# FACPAC Contract Change Order

Tier 1 Project: CHHS Phase 2

15-5

**AIA**<sup>®</sup>**Document G709<sup>™</sup> – 2018****Proposal Request**

EL-3

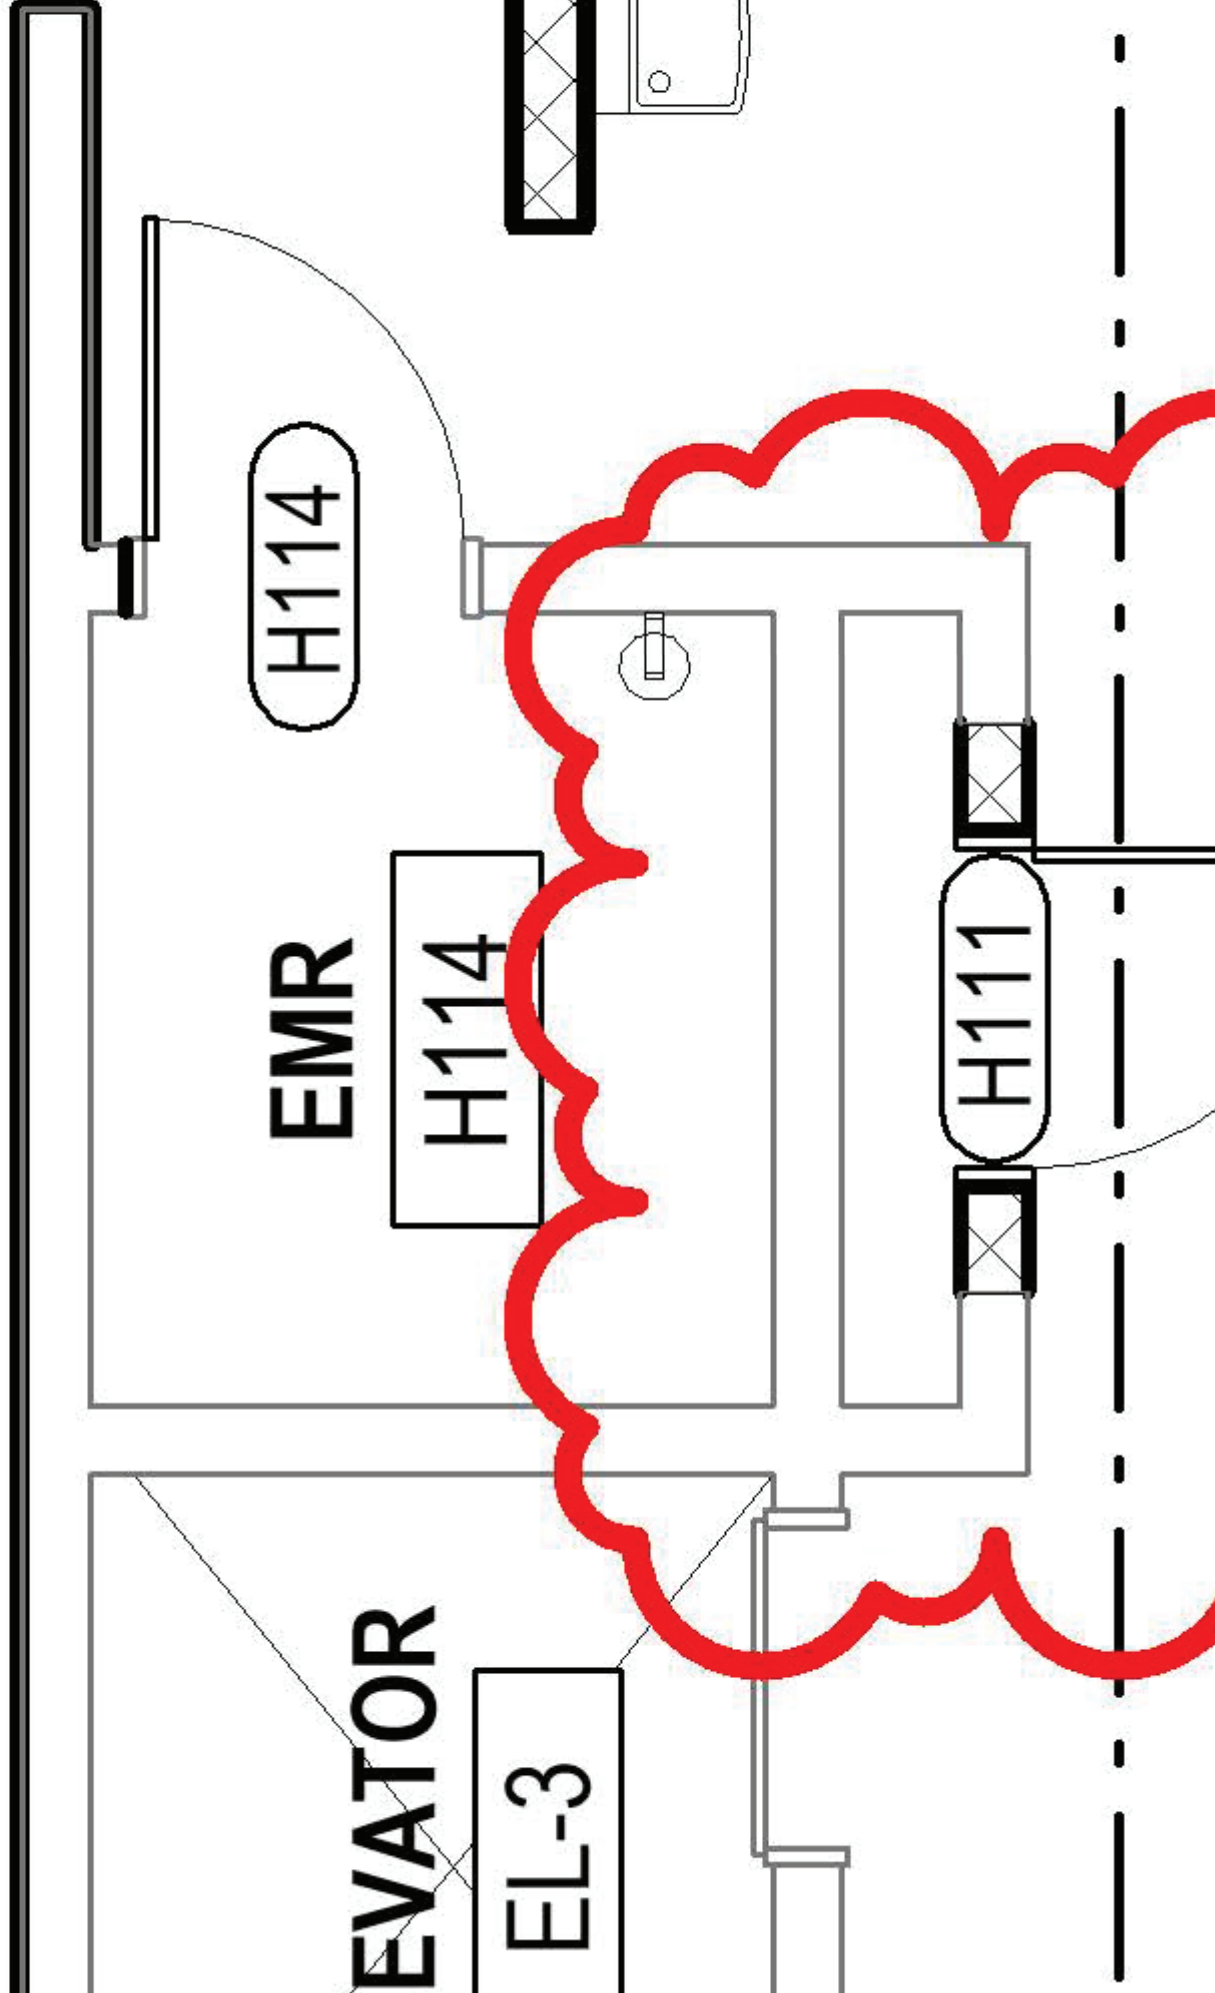
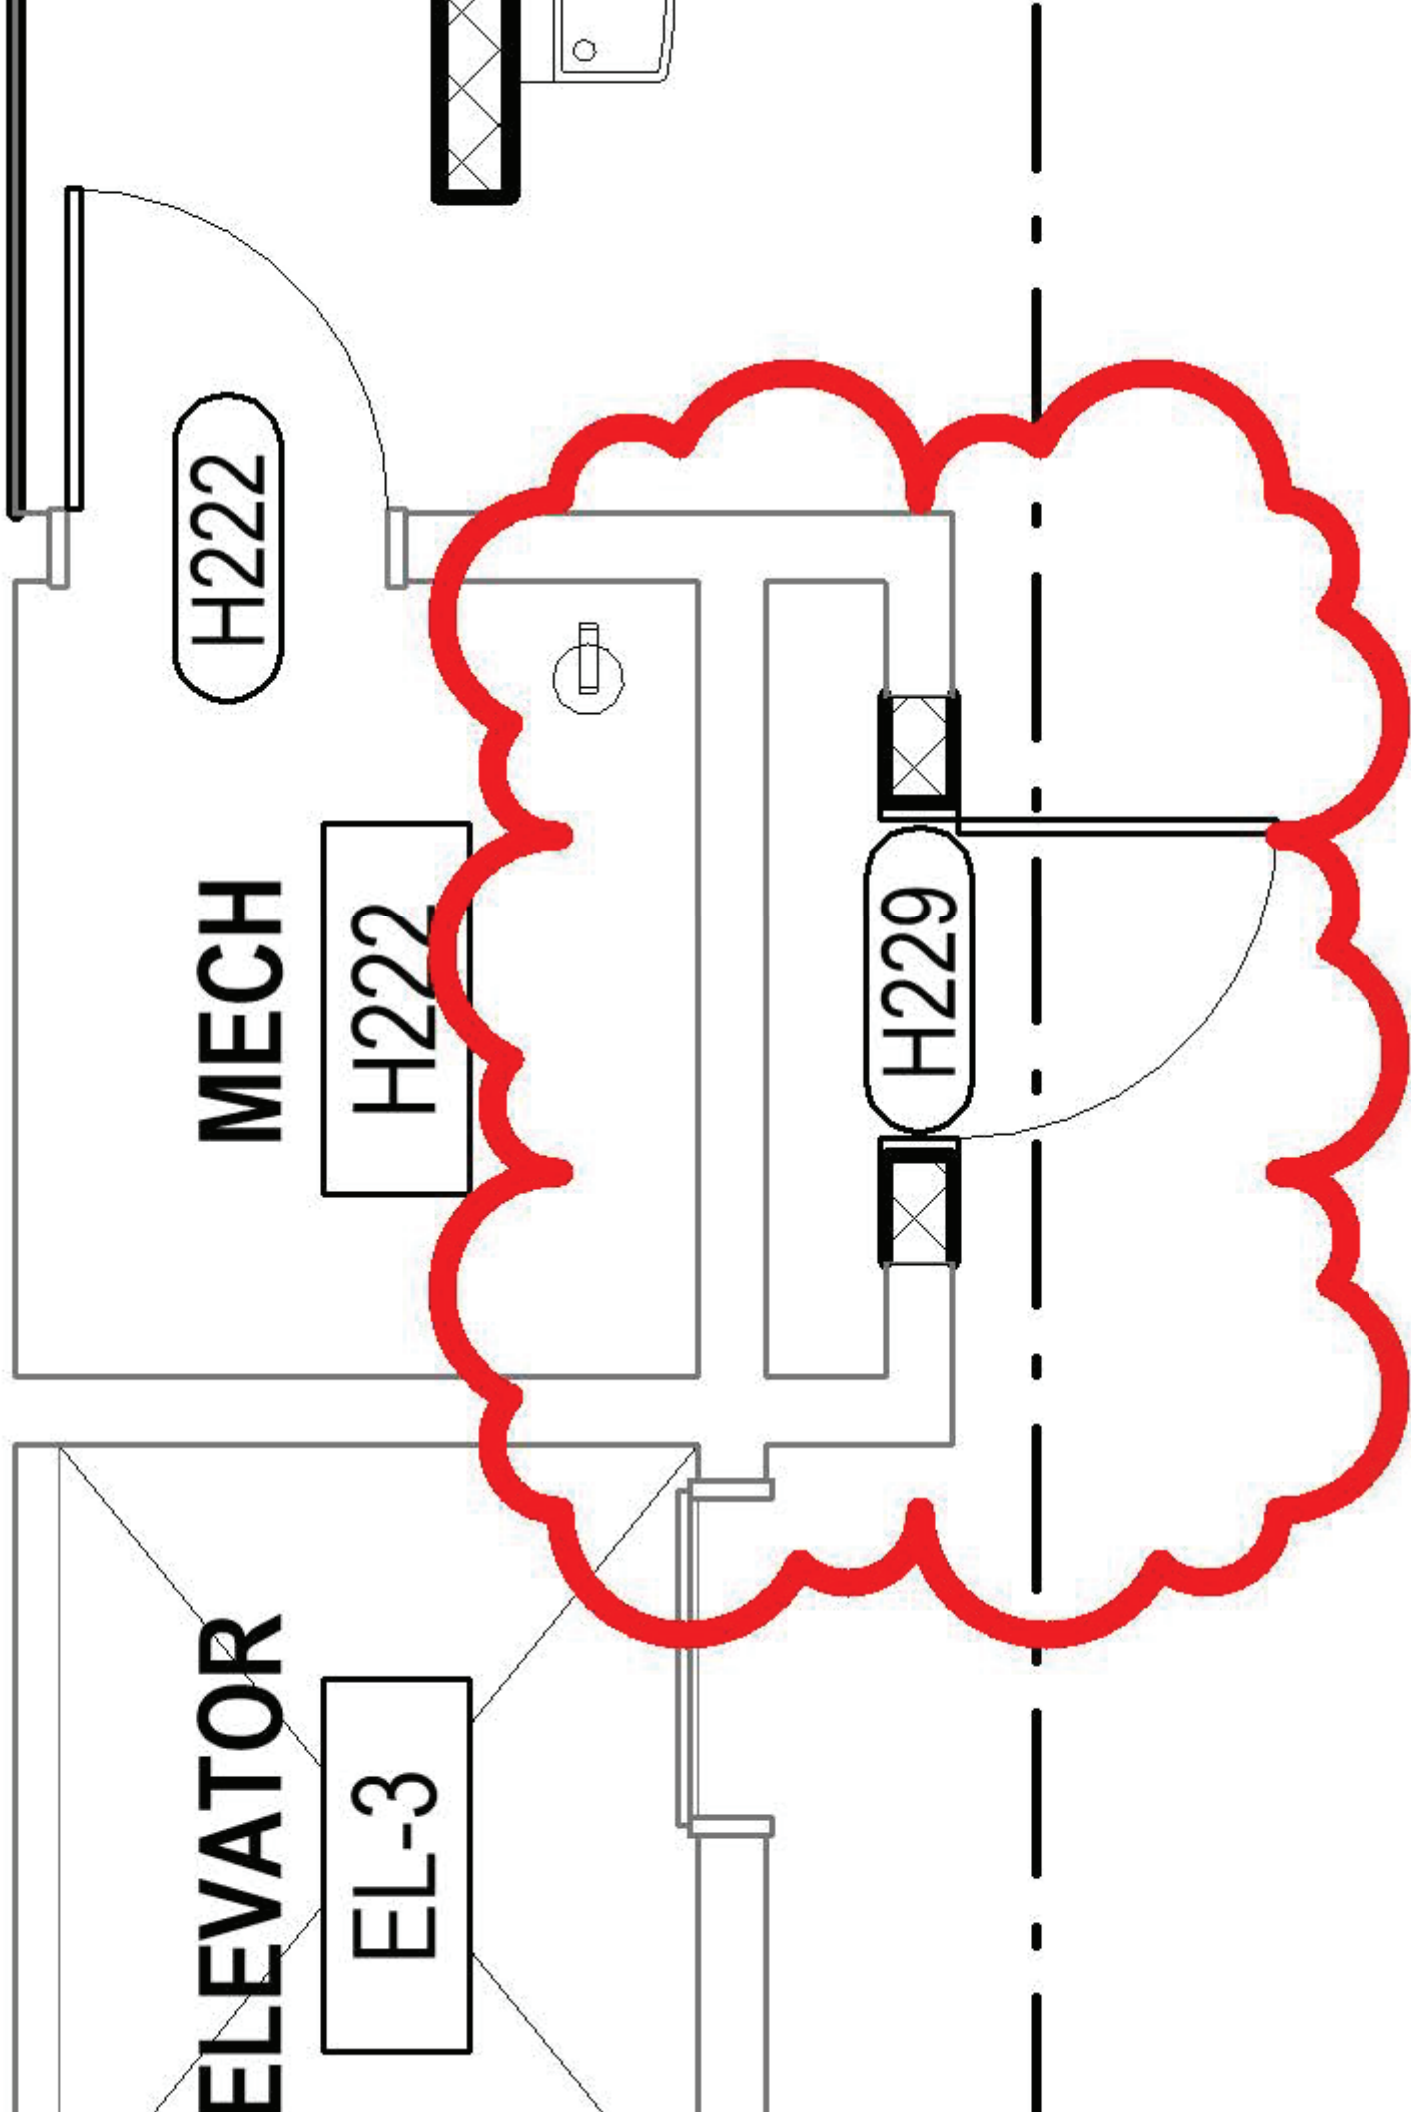
The owner would like to remove 2 display cases and turn them into closets.

Provide pricing for demolition of the sliding window, CMU below and bottom of display case. Provide a 3'-0" by 7'-2" single "Type F" wood door with hollow metal frame.

Match door hardware on H215A door. Infill with CMU as required.

Match adjacent finishes and paint interior of room P-1, add B-1 rubber base, RT-1 rubber flooring and add light fixture.

**PR29 - Add (1) F1 light fixture in each of (2) new closets**

\*Light type not specified, we have quoted an F1 fixture  
 \*No lighting controls included  
 \*Lights will tie into closest circuit and operate off internal motion sensor
